STAFF REPORT
(One-Step Final Plat)

CASE NUMBER: S/D 99-36 - CHENEY BAPTIST CHURCH FIRST ADDITION

OWNER/APPLICANT: Cheney Baptist Church, Box 551, Cheney, KS 67025

SURVEYOR/ENGINEER: Macon Company, 200 East 4th, Newton, KS 67114

VICINITY MAP

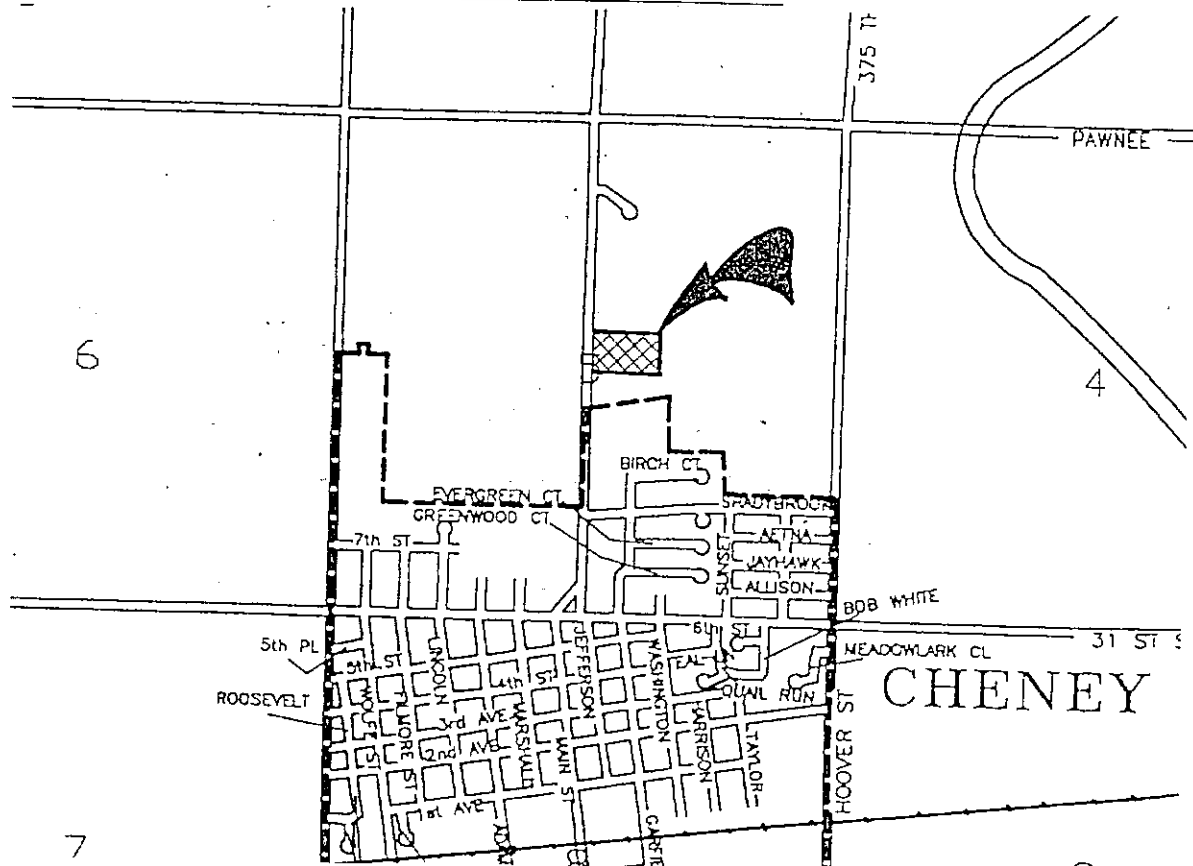
- D. The name of the adjoining street - 383rd St. West - shall be denoted, along with the centerline.
- E. Access control except for one opening shall be dedicated along 383rd St. West and referenced in the plattor's text.

- F. The legal description needs to be revised to accurately portray the land being platted. The distance "707.30" should be "762.30".
- G. Since this is not a replat of various public reservations, the plattor's should not make reference to KSA 12-512(b).
